CDM: Recommendation Form for Small Scale Methodologies (version 01)

Date of SSC WG meeting:	21–24 September 2009, SSC WG 22
Title/Subject (give a small title or specify the subject of your submission, maximum 200 characters):	Clarification on the applicability of AMS-I.C regarding a back-up unit for consideration of installed capacity limit
Indicative methodology to which your submission relates (refer the items of Appendix B of the Simplified Modalities and Procedures), if applicable.	AMS-I.C, version 14
Name of the authors of the query:	Ryoto Uchida Institution: Mitsubishi UFJ Securities Co., Ltd. uchida-ryoto@sc.mufg.jp

SSC-Submission number	SSC_336
Date when the form was received at UNFCCC secretariat	24 September 2009
Date of transmission to the EB	24 September 2009
Date of posting in the UNFCCC CDM web site	24 September 2009

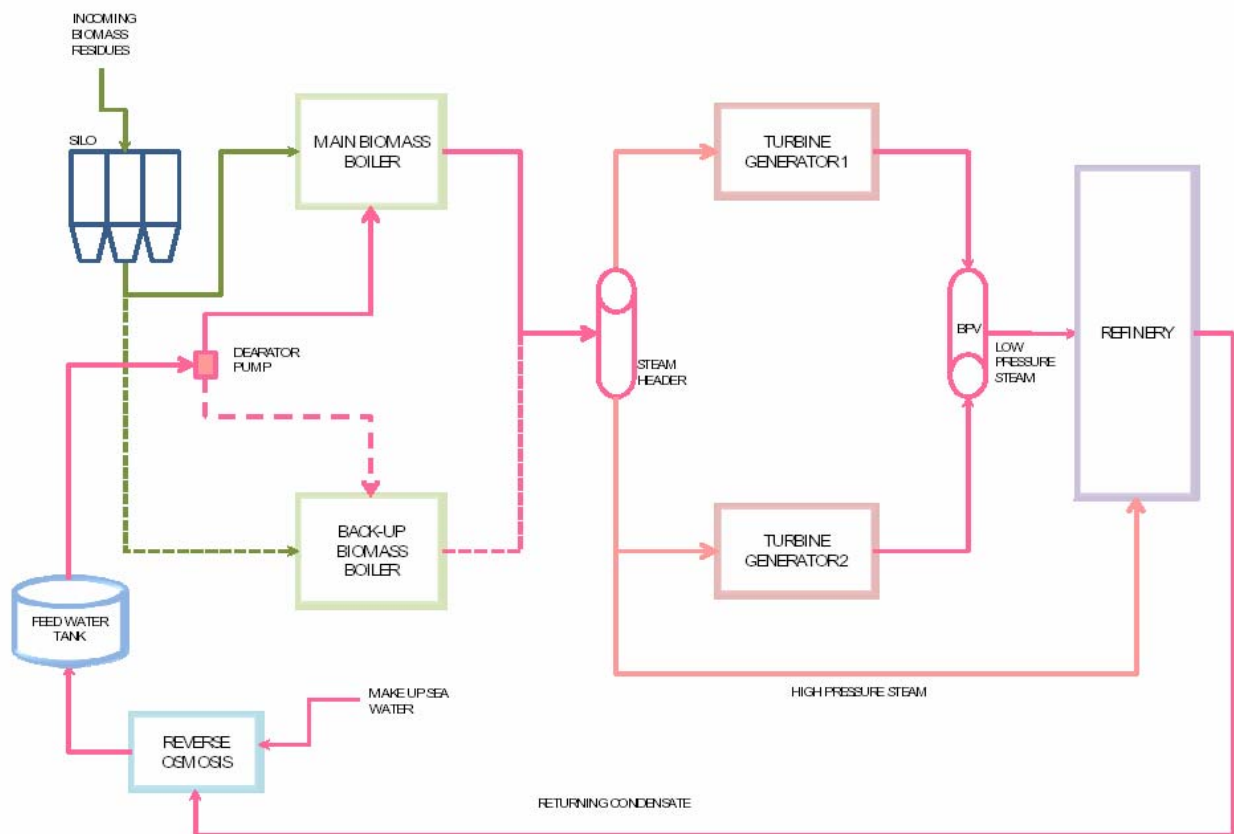
To increase the reliability and maintain constant energy output for the end product at the refinery, one stand-by system (consisting of a boiler, turbine, and generator with the same capacity as the main system) is made available, which allows full maintenance to be conducted on the main boiler and turbine generator while they are off operation. All steam generated by the biomass boilers goes through one steam header and is fed to either of the steam turbine generators and the refinery. The system diagram is as shown below:

This is a request to clarify the following two points;

- (a) The five criteria for a back-up unit, to be proposed hereunder, are appropriately established, so that the back-up unit that meets all the criteria can be excluded from consideration in the determination of installed capacity limits when AMS-I.C is applied.
- (b) The back-up biomass boiler in the project described above meets all the proposed criteria and therefore can be excluded from consideration in the determination of installed capacity to satisfy the energy output limit stipulated in AMS-I.C.

From a safety point of view, only one boiler can be operated at a time in the project activity. It is not possible to have more than one boilers operated because of the following technical limitations;

- a. The installed steam header (diameter 300mm) to receive all steam from the boilers is designed to allow only one boiler in operation. Operation of two boilers will put the plant in a dangerous condition where the pressure drop between boiler outlet and steam header off-take increases to 0.2 bar (should be kept less than 0.1 bar) and the steam velocity reaches its upper limit of 15 m/s. The steam header with diameter of 400mm is required for two boilers operation in order to avoid the pressure drop and keep the velocity as low as 8 m/s.*

- b. The capacity of dearator pump to supply water to the boilers is only 50 tons of water per hour whereas the capacity of 80 tons/hour is needed to operate two boilers.*

- c. The R/O (Reverse Osmosis) used in the common system to supply water to the boilers has too small capacity (50 m3/hour) to allow more-than-one boilers in operation continuously.*

The SSC WG noted that all high pressure steam generated by the biomass boilers (main and back up) goes through a common steam header and is fed:

- (a) to one of the steam turbine generators i.e., turbine generator 1 or turbine generator 2; and the rest to
- (b) to the refinery

The SSC WG clarifies that stand-by (or backup) unit(s)/system(s) shall be excluded from consideration in the determination of installed capacity limits and debundling check if and only if, the following conditions are all met:

- (a) The back-up unit(s)/system(s) are included in the boundary and operated in substitution for the main unit(s) only, with no simultaneous operation;

- (b) The back-up unit(s)/system(s) in total have an output capacity less than or equal to the main unit(s);
- (c) No emission reductions are attributed to any operation of the back up unit(s)/systems(s) during the crediting period;

- (d) The energy generated by the main and back-up unit(s)/system(s) flows through 'common systems' (e.g., steam header, electrical bus bar etc.); the 'common systems' shall have a capacity limit such that it allows only transmission of the input/output at any given time from either the main or back-up unit(s)/system(s), i.e., only input/output either from the main or from the back up unit/system (but not from both) can be transmitted at any given time;

- (e) The energy output from the main unit and the backup unit(s)/system(s) shall be continuously metered separately with calibrated equipment.
